Subject: Grand Gulf Nuclear Station
Unit 1
Docket No. 50-416
License No. NPF-29
Additional Information Concerning Primary Containment
Penetration
Conductor Overcurrent Protective Devices Technical
Specification Change Under Exigent Circumstances
Proposed Amendment to the Operating License (PCOL-92/04)

GNRO-92/00060

Attachments: 1. Response to NRC Questions
2. Coordination Curve for PCOL 92/4

COORDINATION CURVE FOR PCOL 92/4 TIME-CURRENT CHARACTERISTIC CURVES

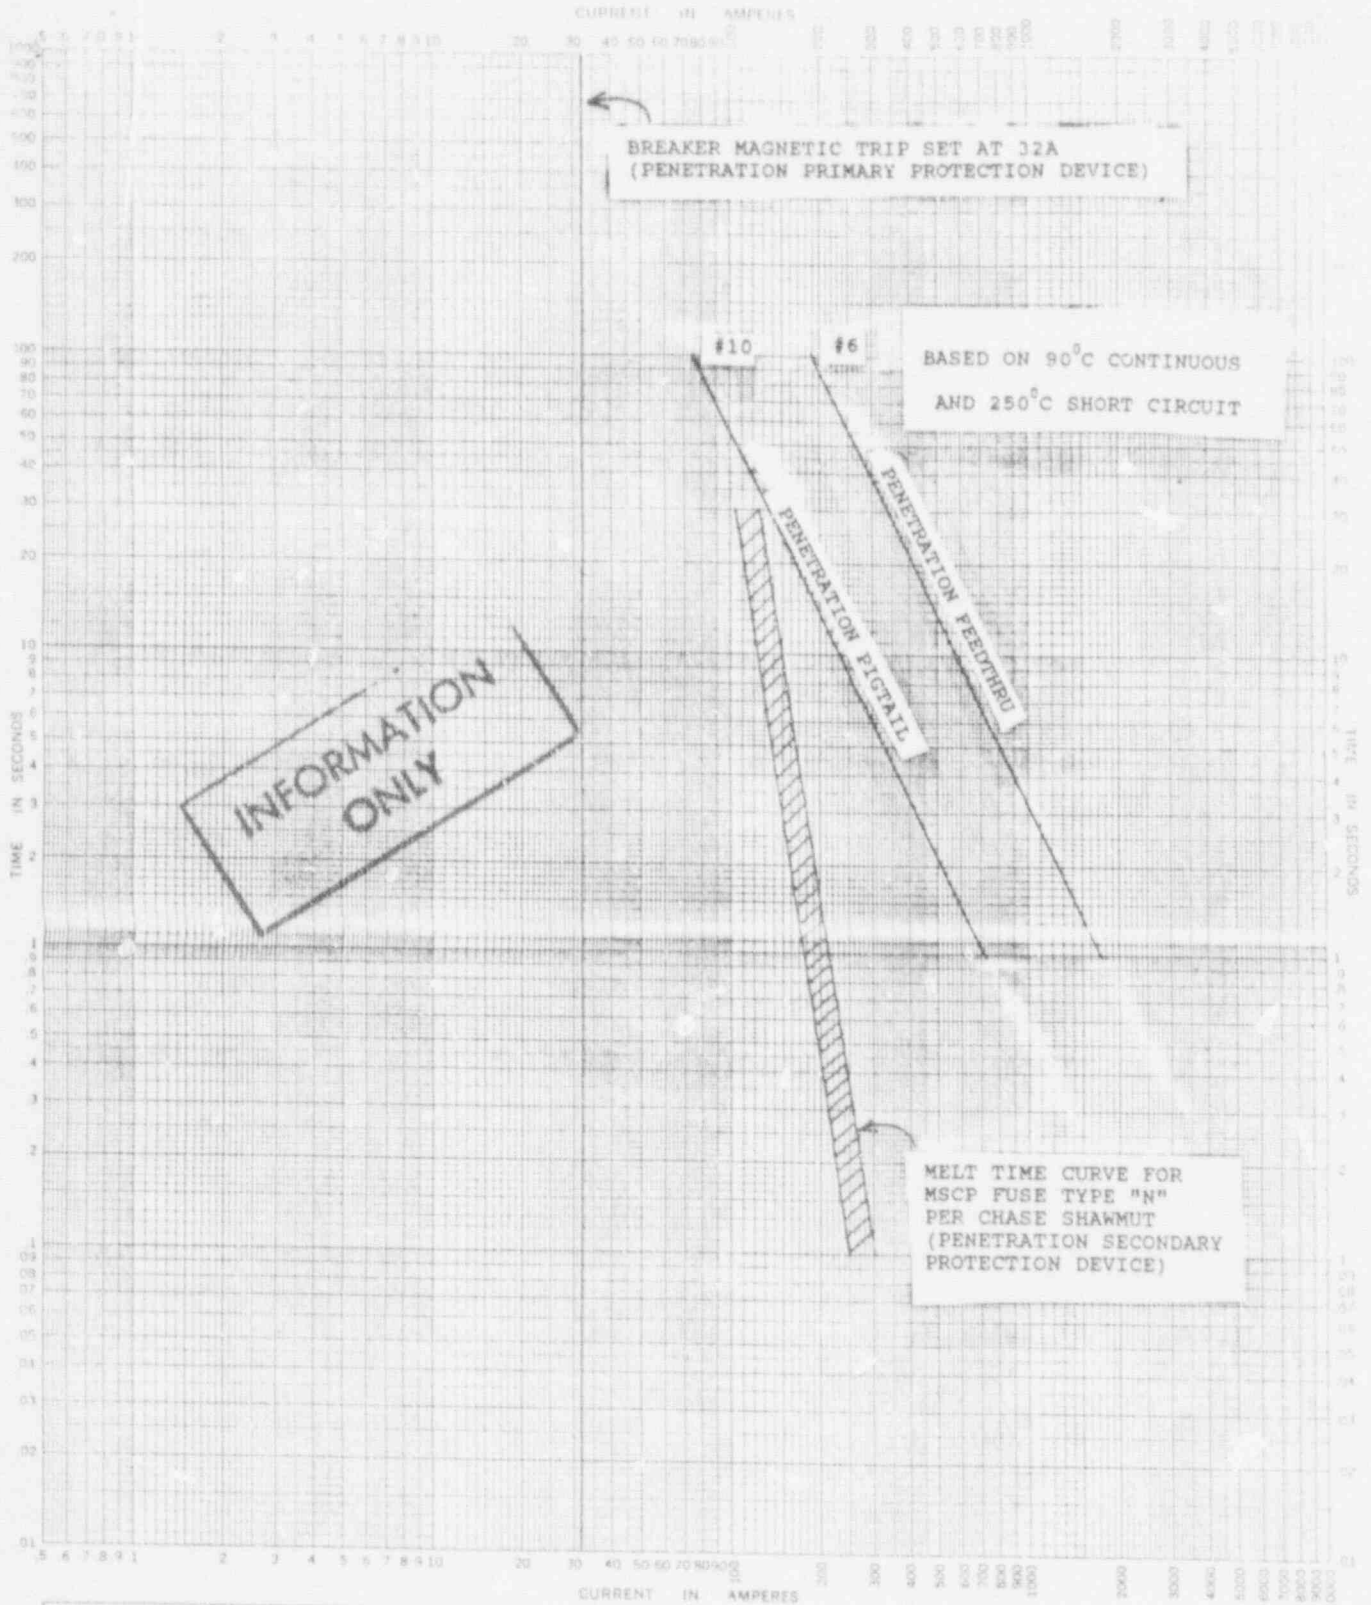
1. A time-current coordination curve showing both the primary containment electrical penetration assemblies and the proposed breaker setting, and

2. A definitive statement that the proposed breaker trip setpoints provided an adequate margin between the operation of the breakers and the rating of the primary containment electrical penetration assemblies.

1. Attachment 2 to this letter provides time-current coordination curves of the proposed breaker trip setpoints in comparison to the associated backup overcurrent protection and the primary containment electrical penetration assemblies being protected. The information on Attachment 2 was developed for your use from design information and is typical for the affected containment penetrations.

2. The primary containment electrical penetration assemblies affected by the proposed Technical Specification change are constructed with a #6 AWG feedthru conductor. Attachment 2 shows the ratings of the feed thru conductors for postulated short circuit fault currents. As shown by Attachment 2, the proposed trip setpoints for these breakers of 32A, is within the ratings of the feedthru conductors for postulated short circuit fault currents, thereby, assuring adequate protection of the affected electrical penetration assemblies.

Another part of the primary containment electrical penetration assemblies are their associated pigtail conductors. The pigtail conductors link the feed thru conductors to the rest of the circuit. The proposed changes in the design of these circuits also protects these conductors. The primary containment electrical penetration assemblies affected by the proposed Technical Specification change are constructed with a #10 AWG pigtail conductor. The full load current (FLA) rating for the new valve actuator motor is 2.3A at 460 volts (V). The approximate locked rotor current is 6 X FLA or 13.8A. Per the GGNS Specification for Containment Penetrations, the #10 AWG pigtail is rated to carry 17A continuously (as shown on Attachment 2 the fault current rating is much higher) under both normal and accident conditions. Therefore, this conductor is rated to conduct the locked rotor current of the subject motors for an indefinite period of time. This bounds any postulated overload condition. Attachment 2 shows the ratings of the pigtail conductors for postulated short circuit fault currents. As shown by Attachment 2, the proposed trip setpoints for these breakers of 32A, is within the ratings of the pigtail conductors for postulated short circuit fault currents, thereby, assuring adequate protection of the affected electrical penetration assemblies.

As shown by Attachment 2, should a fault occur on the feeder cable on the containment side of the penetration, the primary and secondary penetration protection devices will limit this fault current to acceptable levels thus protecting both the penetration

pigtail and feedthru conductors as indicated on the attached diagram. The proposed trip setpoints for these breakers of 32A, is within the ratings of the primary containment electrical penetration assemblies for postulated short circuit fault currents, thereby, assuring adequate protection of the affected assemblies.
